MFN 09-127

Docket No. 52-010

**Subject: Response to Portion of NRC Request for Additional Information
Letter No. 279 - Related To ESBWR Design Certification
Application – RAI Number 21.6-98 Supplement 1**

RAI Number 21.6-98 S01

Figure 2.15.4-1. Passive Containment Cooling System Schematic

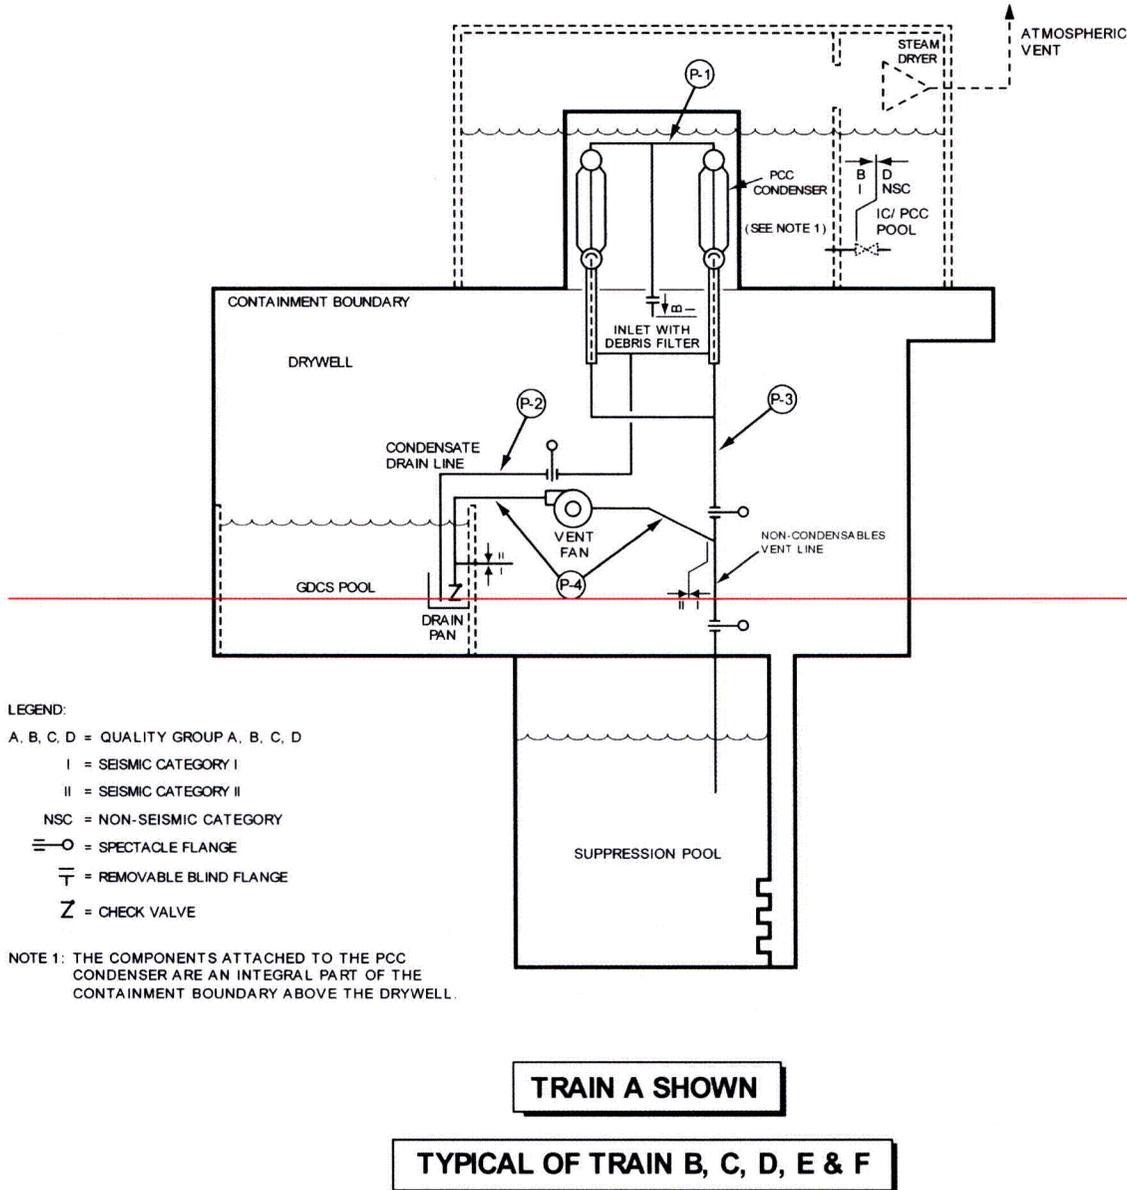
Confirmatory Item 19: Reference 1.7 in GEH's response does not exist. RAI 21.6-102 response was sent in MFN 07-349 dated June 19, 2007 in response to NRC RAI Letter 96. Please clarify and correct if GEH meant to refer to RAI 21.6-106 (in MFN 08-338, dated April 7, 2008 in response to NRC RAI Letter 120). If RAI 21.6-106 is the correct reference, it states that "[a]s an additional enhancement to improve steam condensation discharged through the PCCS vents in the SP, the current ESBWR design includes spargers on each vent." ESBWR DCD Tier 2 Revision 5 Table 2.15.4-1 refers to ESBWR DCD Tier 2 Revision 5 Figure 2.15.4-1 for equipment identification of these spargers. However, Figure 2.15.4-1 does not show spargers. Update ESBWR DCD Tier 2 Figure 2.15.4-1 to show the spargers.

This LTR is referred in the ESBWR DCD Tier 2, Section 6.2.9 as Reference 6.2-11. ESBWR DCD Tier 2, Subsection 6.2.1.1.3 and Subsection 6.2.9 will be revised. In addition, ESBWR DCD Tier 1 Figure 2.15.4-1 will be modified to include the sparger.

Note: Figure 2.15.4-1 refers to ESBWR DCD Tier 1 instead of Tier 2.

ESBWR DCD Tier 1, Figure 2.15.4-1 will be revised as noted in the DCD markups in Enclosure 3.
